DRAWINGS:

REMARKS

The enclosed is responsive to the Examiner's Final Office Action mailed on April 21, 2005 and is being filed pursuant to a Request for Continued Examination (RCE) as provided under 37 CFR 1.114. At the time the Examiner mailed the Office Action claims 1-22 were pending. By way of the present response the Applicants have: 1) amended claims 1, 8, and 14; 2) added no new claims; and 3) canceled no claims. As such, claims 1-22 are now pending. The Applicants respectfully request reconsideration of the present application and the allowance of all claims now presented.

FIG. 9

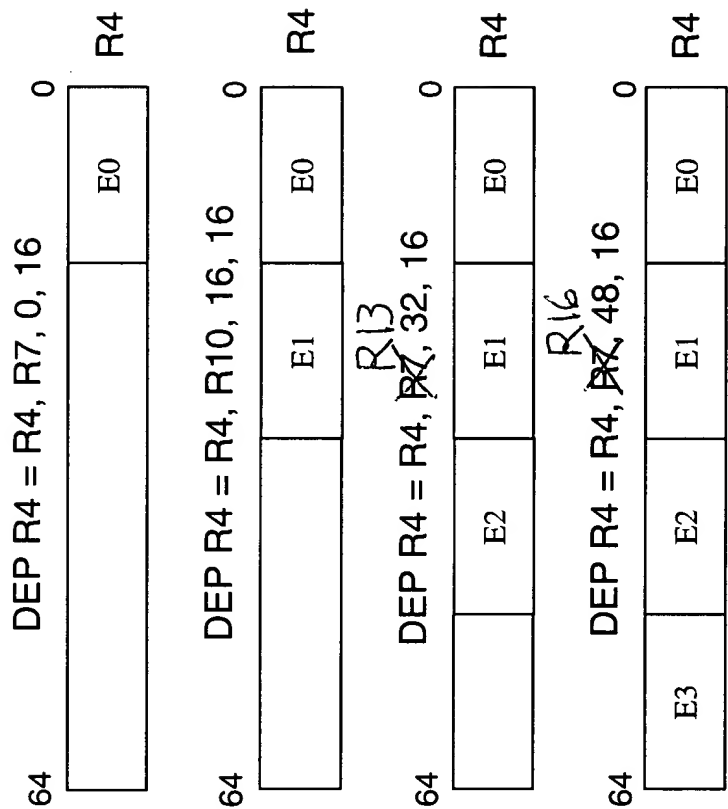
Figure 9 has been amended to correct typographical errors. "R7" of the third and fourth DEP operations have been replaced with "R13" and "R16", respectively. The third operation should now read as "DEP R4 = R4, R13, 32, 16", and the fourth operation should now read as "DEP R4 = R4, R16, 48, 16".

Amendments to **Figure 9** are fully supported in the original specification on page 11, paragraphs 2 and 3, and **Figure 8**. For example, the explanation of **Figure 9** on page 11 of the specification states, "...a series of deposit operations copy, in succession, E0, E1, E2, and E3 into register R4." **Figure 8** is explained illustrates that E2 and E3 were held in R13 and R16, respectively. Prior to amendment, **Figure 9** mistakenly illustrated R7 in the third and fourth operation instead of R13 and R16, where E2 and E3 are held.

The above amendments do not add any new matter. They merely correct typographical errors. A clean version of **Figure 9** has been enclosed in addition to the redline copy.
